To: Honorable Mayor Bill Agan and members of the Richland Hills City Council
From: Jason Moore, Assistant City Manager
Date: November 22, 2016
Subject: Approval of Change Order #07 for the Link Project

Change Order

PROJECT <i>(Name and address):</i> Richland Hills Activities Center Richland Hills, TX	CHANGE ORDER NUMBER: 007 DATE: November 16, 2016	OWNER: <input checked="" type="checkbox"/> ARCHITECT: <input checked="" type="checkbox"/>
TO CONTRACTOR <i>(Name and address):</i> Thos. S. Byrne, Inc. 2601 Scott Ave., Suite 300 Fort Worth, TX 76103	ARCHITECT'S PROJECT NUMBER: 2014.01.001 CONTRACT DATE: October 20, 2015 CONTRACT FOR: New Construction	CONTRACTOR: <input checked="" type="checkbox"/> FIELD: <input type="checkbox"/> OWNER'S REP: <input checked="" type="checkbox"/>

Cost Estimate Summary Sheet
Richland Hills Activity Center - Phase 2
50% CD Estimate

Sheet title:
HARDSCAPE & SITE AMENITY PLAN PHASE 2
L2.02

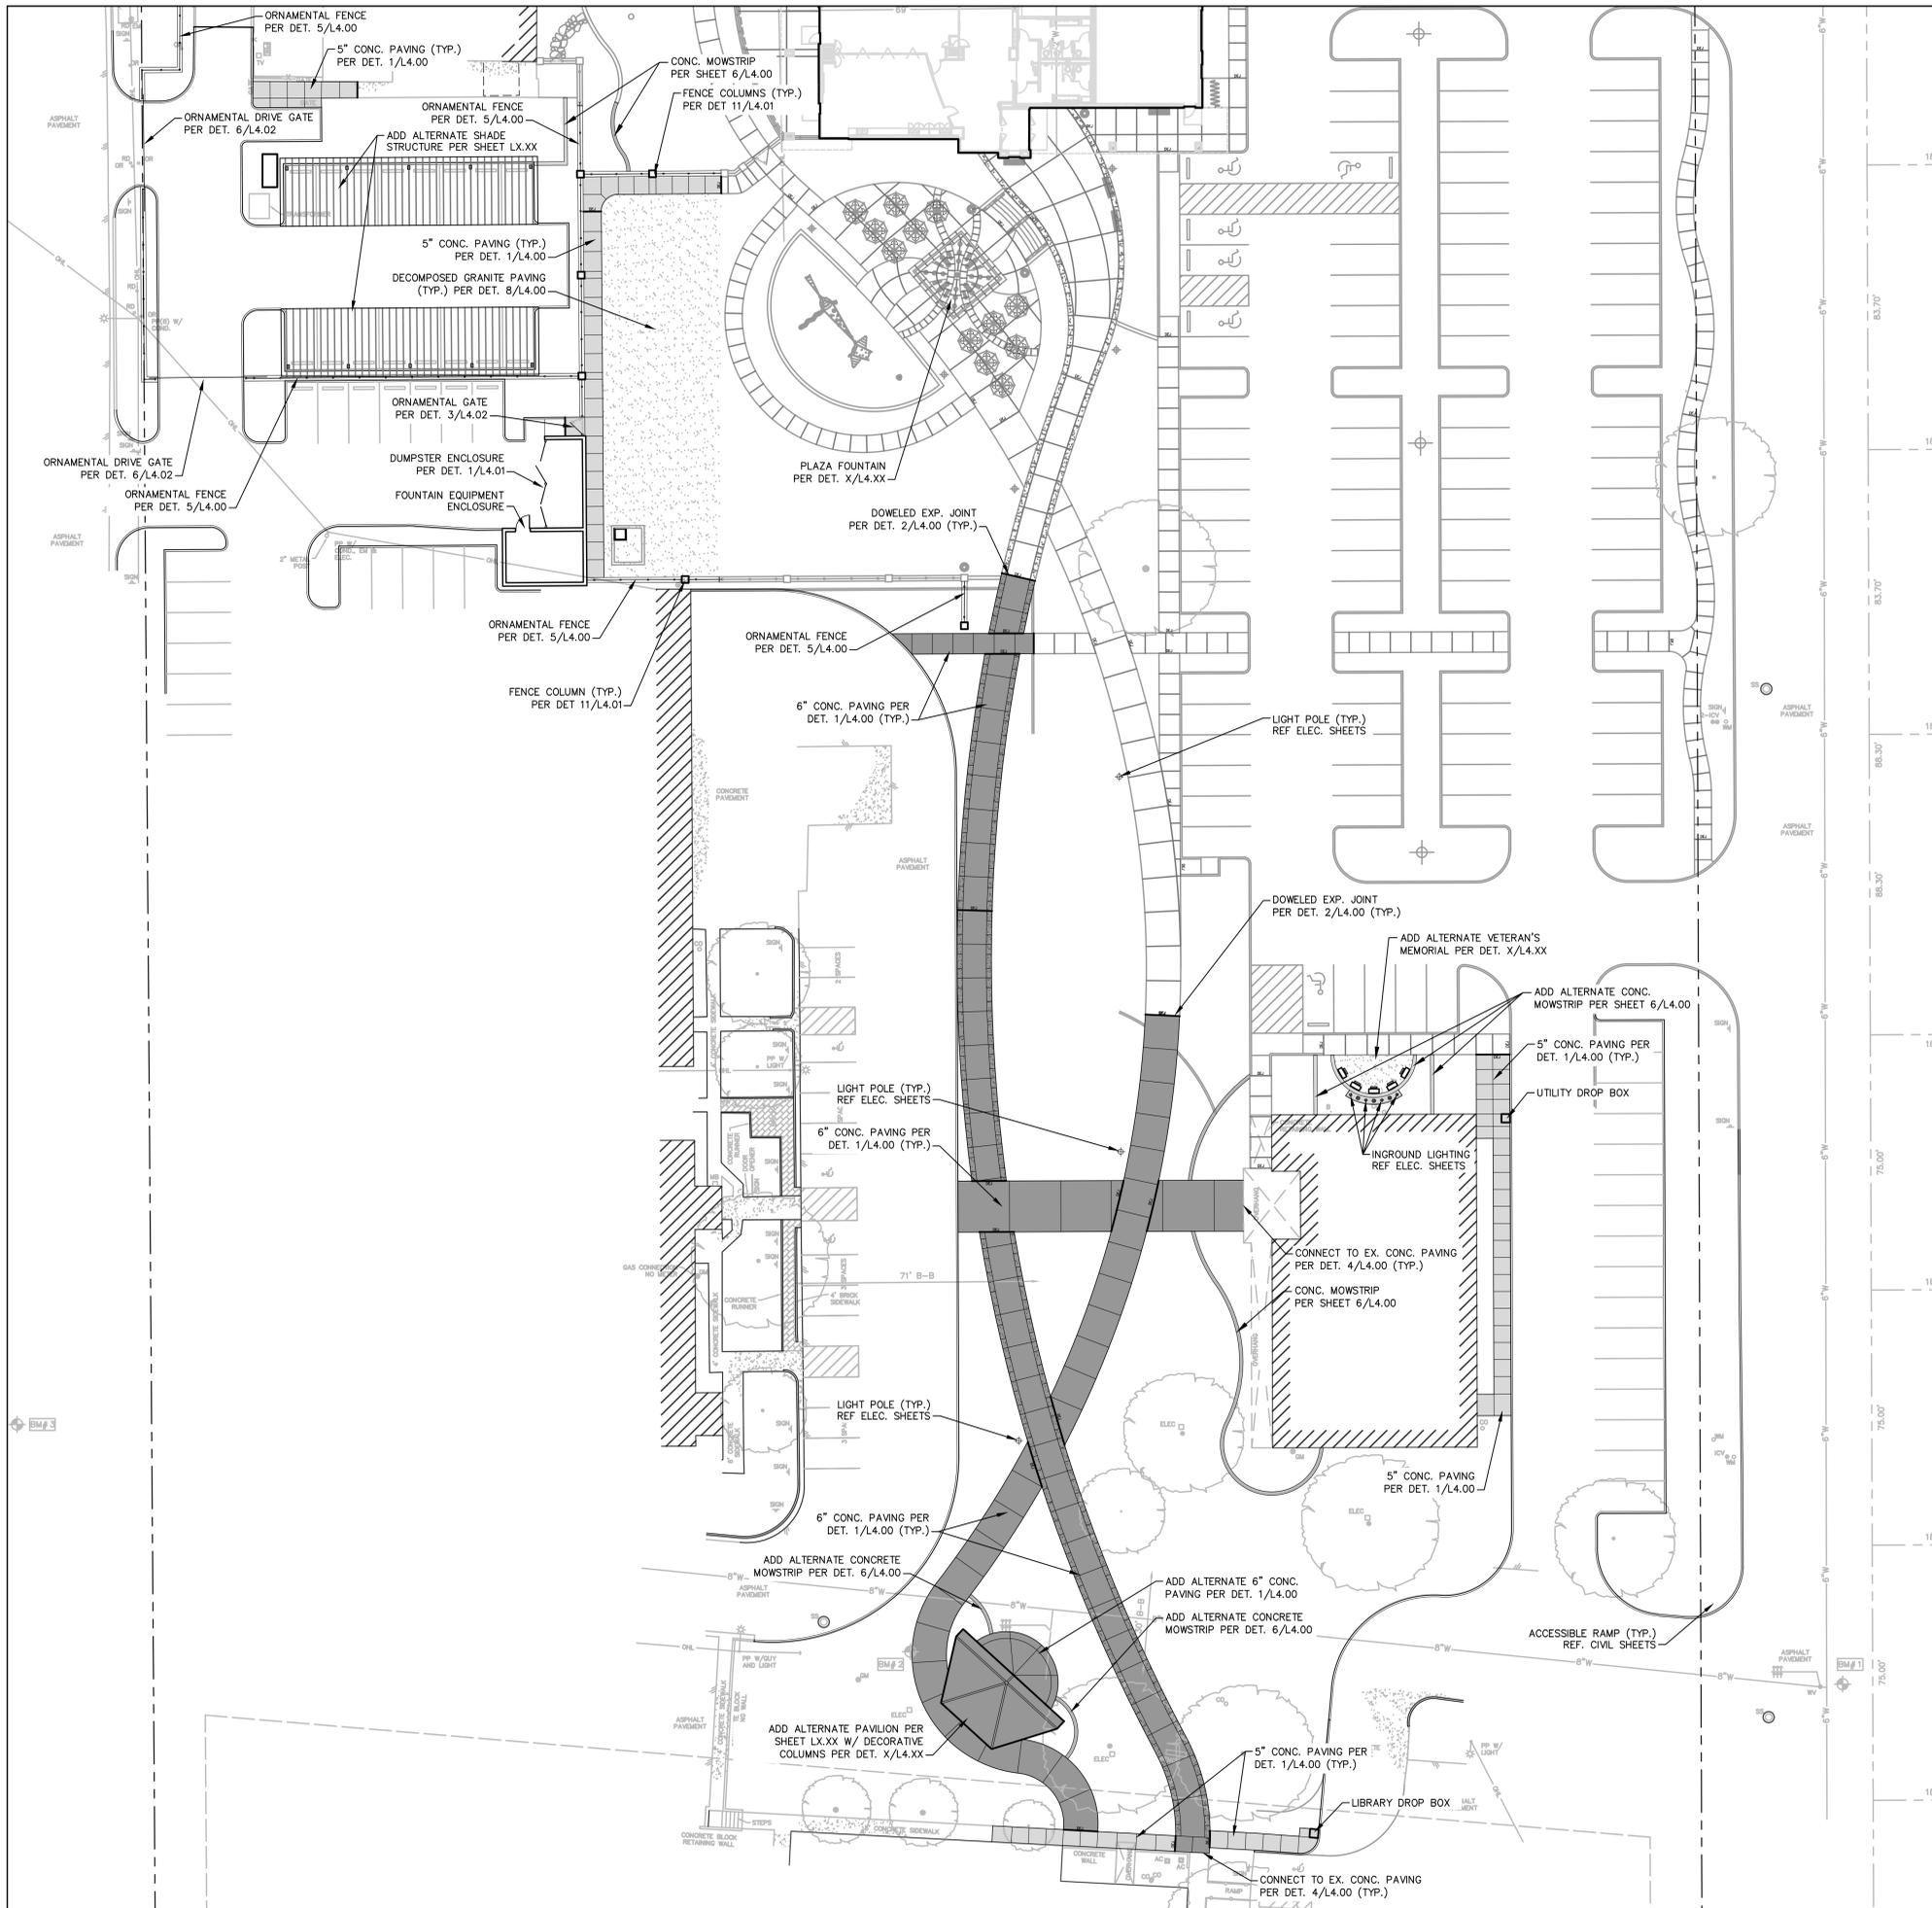
Background Information: Change Order #7 is in response to the City's request to add the Phase 2 scope to the Link project. As you will recall, phase 2 involves the park plaza linking the entire municipal complex together. As a refresher, the site plan is attached to this memo for your review.

(Include, where applicable, any undisputed amount attributable to previously executed Construction Change Directives)
This Change Order amends the GMP to include Phase II of the Richland Hills Activities Center. Please reference attached Phase II - 50% CD Estimate documents dated November 16, 2016 for definition of scope, schedule, clarifications and qualifications.
